## Product Change Notice (PCN)

**Subject:** Metal Spin and Change in RDL Design and PI Materials

**Publication Date:** 6/16/2023

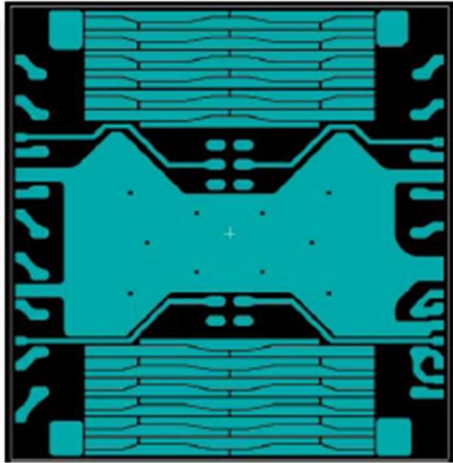
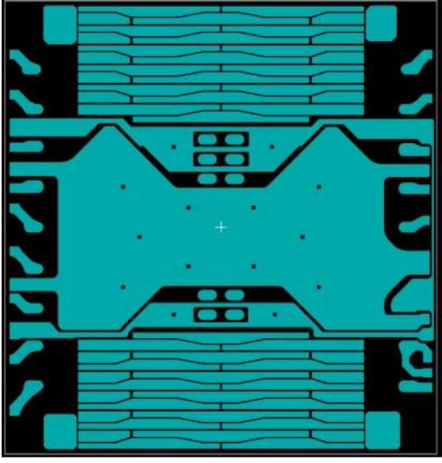
Renesas has made a metal spin to fix the ADC stuck and I2C issue. In addition, there are modifications made on the RDL layout and PI materials.

Current	New
Ordering Part#	P8900-X0Z001FNG P8900-X0Z001FNG8	P8900-X1Z001FNG P8900-X1Z001FNG8
RDL Design		
PI1 & PI2 Material	High temp cure material, HD4100	Low temp cure material, LTC9320
